Safety Recall Notice

Some **Civia Bryant and Hyland** bicycles were sold equipped with disc brakes and a front quick release lever that can come into contact with the front disc brake when improperly adjusted or left open while riding. An example of a bicycle with a front quick-release cam lever that is able to be opened far enough to create this potential contact is shown in Figure 1 below. An example of a bicycle with a front quick-release cam lever that does not have the potential for contact with the disc brake is shown in Figure 2. When a quick release like the one shown in Figure 1 is improperly adjusted or left open on a bicycle which also has a front disc brake, the quick release lever can become caught in the front disc brake assembly. If this happens, the front wheel could separate or come to a sudden stop and the rider could lose control of the bicycle posing a serious risk of injury.

Figure 1. Quick-release lever with potential for contact

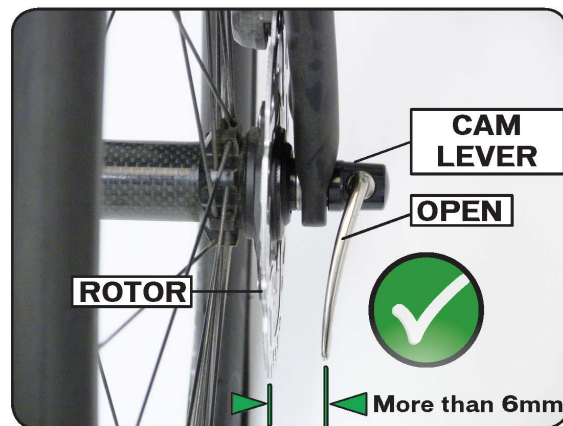
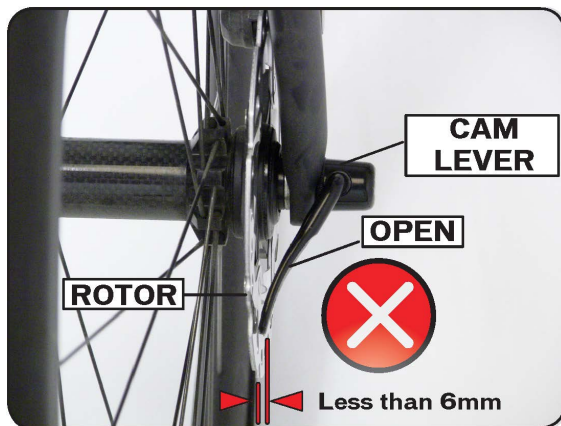
AFFECTED MODELS: Any Civia Hyland and Civia Bryant bicycle equipped with disc brakes and a front quick release lever that can contact the disc brake assembly when fully opened is subject to this recall. Bicycles with front quick-release cam levers that have a clearance of at least 6 millimeters, which is the width of a #2 pencil, between the edge of the lever in its most open position and the disc brake rotor are not considered affected models. If you can pass a #2 pencil between a fully opened quick release lever and your bike's disc brake rotor, your bike is not an affected model. For a video demonstration of how to check this, please visit www.quickreleaserecall.com.

WHAT CIVIA CYCLES WILL DO FOR OWNERS OF A RECALLED BICYCLE: If you own a bicycle that is subject to this recall, **CIVIA CYCLES** will provide you—through your **local** bicycle retailer—a free replacement quick release, including free installation. Please see your local **bicycle** retailer or contact **CIVIA CYCLES** with questions toll free at 877-311-7686.
